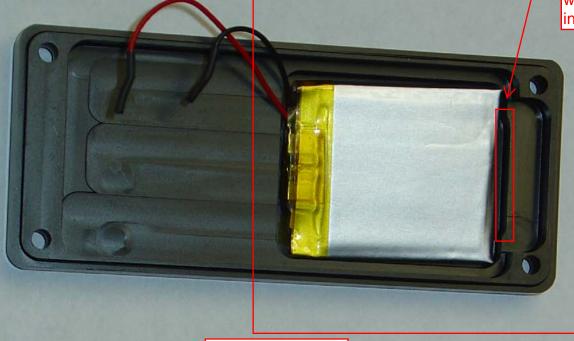
New battery in receiver

We need to discuss this... that small plastic indent will not be present in production units

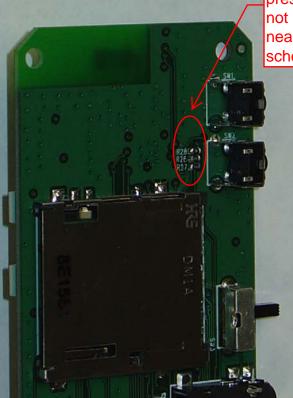
3 parts populated on back of Transmitter PCB. These pads were present in the previous design (but not populated) The circuit and traces nearby nearby were changed (see schematic)
